Table of Contents

Product Change Notification

TE Connectivity

PN 880810-1/-2

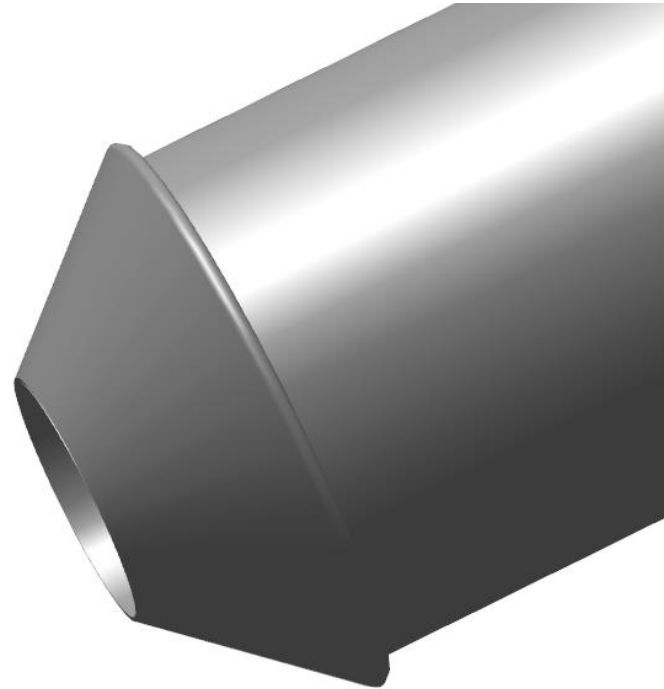
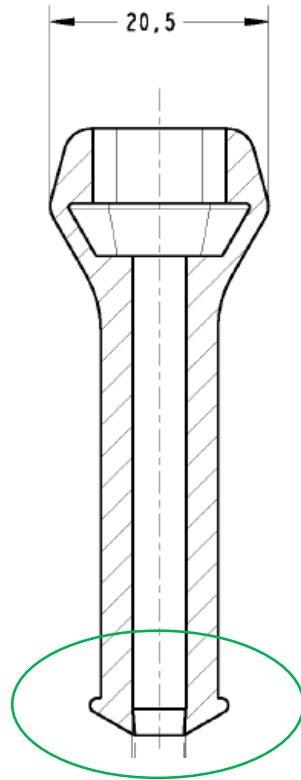
Change design.

Currently design

Proposal design

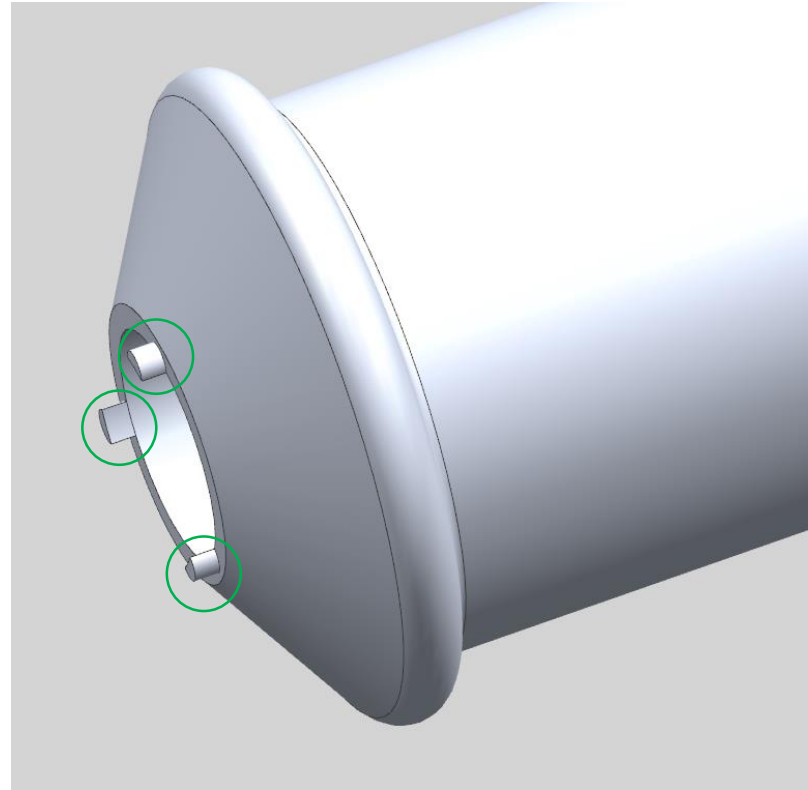
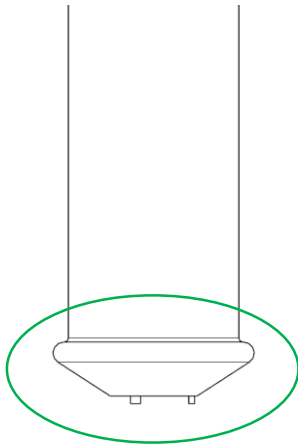
In detail marked in green, we are adding this featured (injection point) for to better injection process.

Proposal design

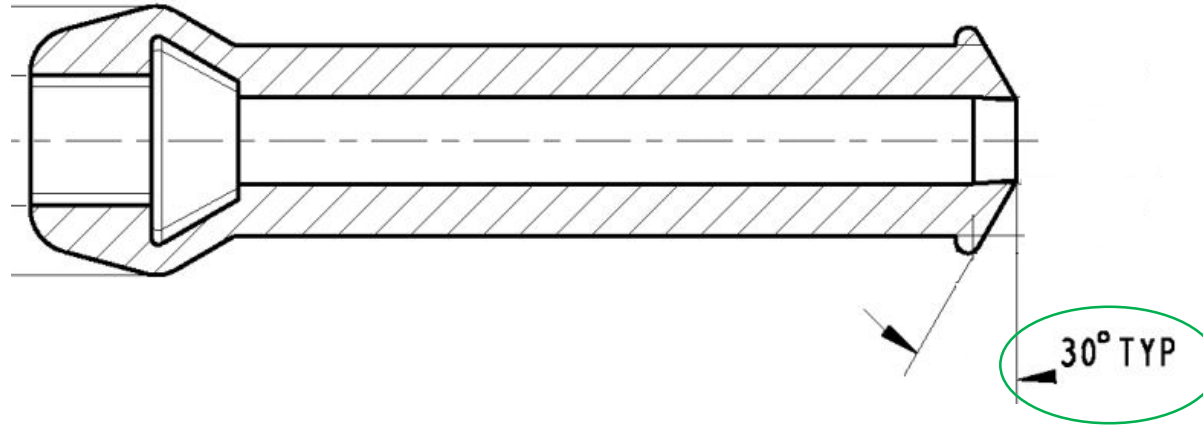
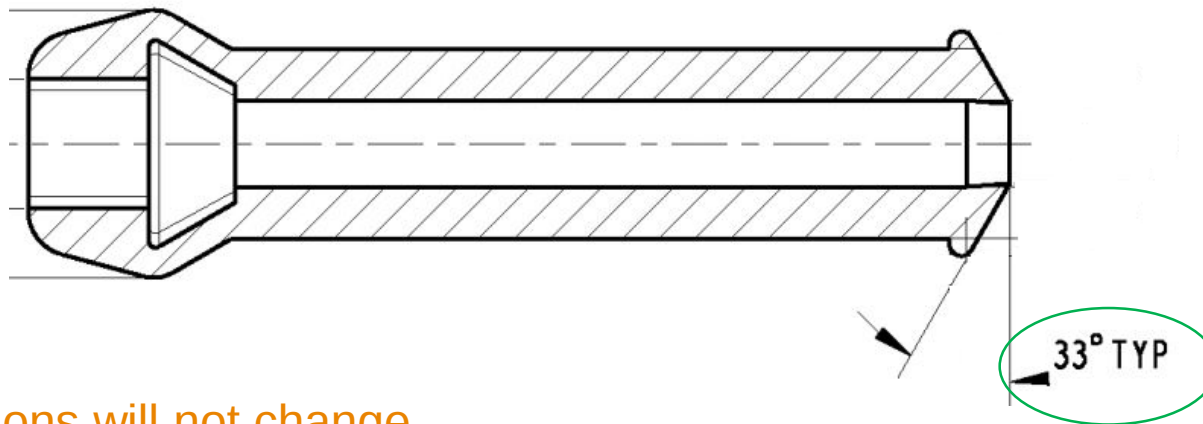
From:

To:

The other dimensions will not change.
